ADDENDUM NO. 2

**HALE PO'AI
BUILDING IMPROVEMENTS**

HPHA JOB NO. 07-031-401-S

March 25, 2010

CONCRETE DECK REPAIR DETAIL

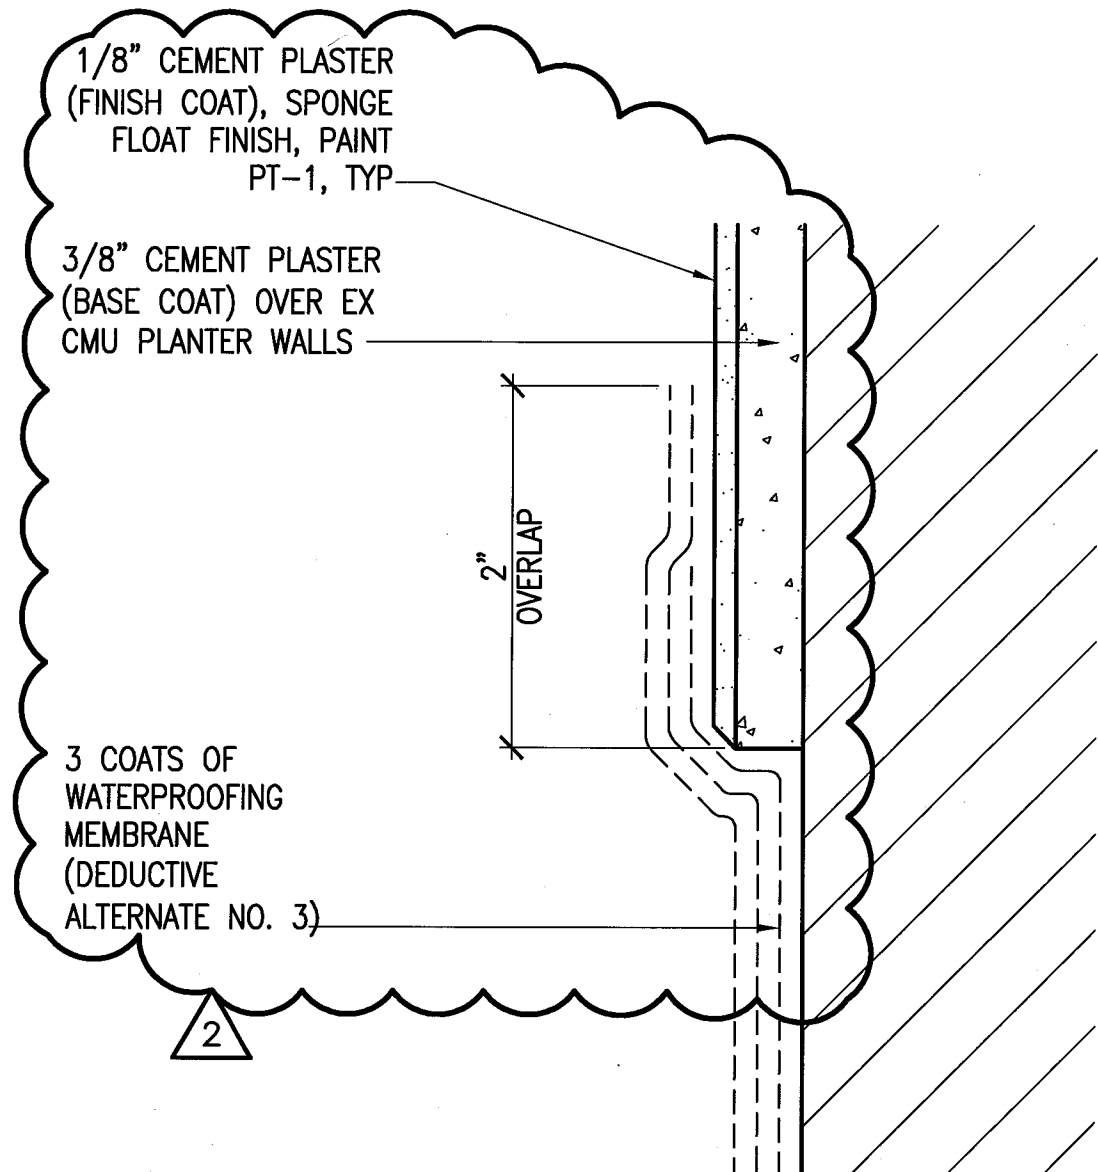
1. Sketch No. 1 (Reference Sheet A7.1 – MISCELLANEOUS DETAILS):
Revise Detail 6/A7.1, Concrete Deck Repair Detail.
2. Sketch No. 2 (Reference Sheet A7.1 – MISCELLANEOUS DETAILS):
Revise Detail 8/A7.1, Waterproof Membrane and Cement Plaster Connection.
3. Sketch No. 3 (Reference Sheet A7.3 – MISCELLANEOUS DETAILS):
Revise Detail 3/A7.3, Bracket Support Detail and Detail 4/A7.3, Bracket Support Detail.
4. Sketch No. 4 (Reference Sheet A7.4 – MISCELLANEOUS DETAILS):
Revise Detail 6/A7.4, Solid Surface Countertop.

REFERENCE SHEET NO.: E2.2
 SKETCH NO. 7
 SK PAGE 7 OF 10

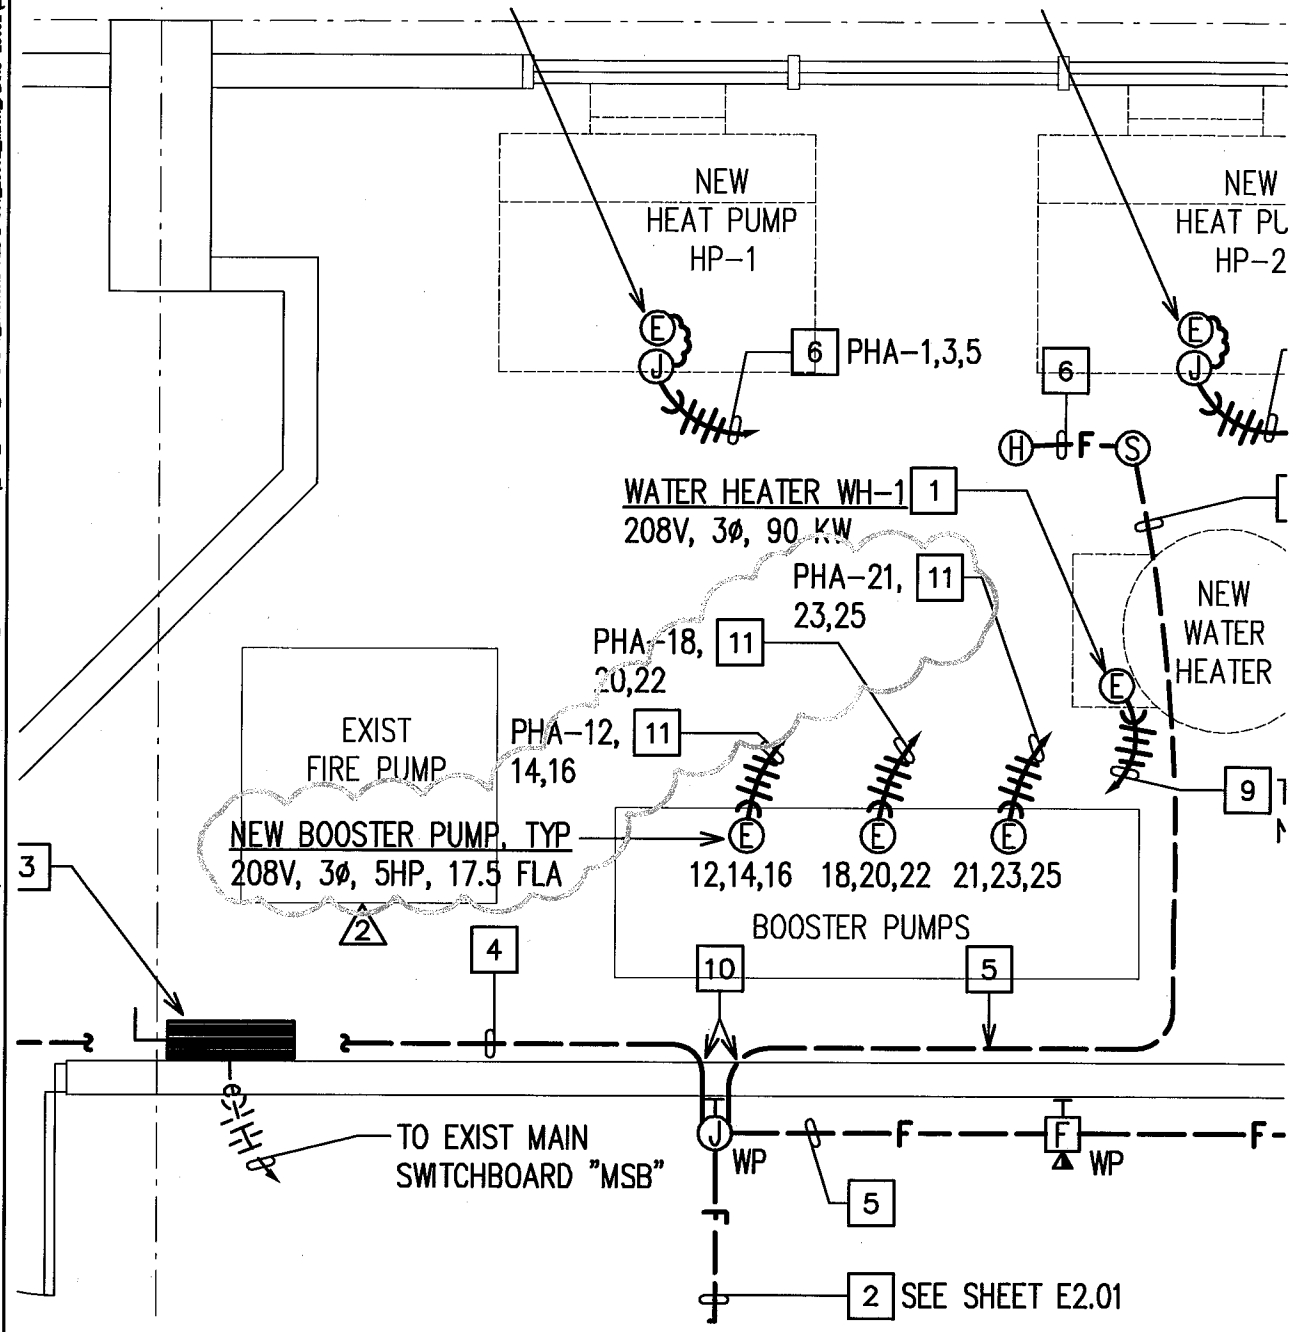
6. Sketch No. 6 (Reference Sheet E1.2 – DEMOLITION PLAN - FIRST FLOOR): Add note to remove the existing fire alarm annunciator.
7. Sketch No. 7 (Reference Sheet E2.2 – ELECTRICAL PLAN - FIRST FLOOR): Revise note to provide a new fire alarm annunciator.
8. Sketch No. 8 (Reference Sheet E3.1 – ELECTRICAL PLANS - MECHANICAL ROOM):
 - a. Electrical Plan - Basement Mechanical Room: Revise the HP rating of the new booster pumps.
9. Sketch No. 9 (Reference Sheet E4.1 – PANEL SCHEDULES): Revise the breaker sizes for the new booster bumps.
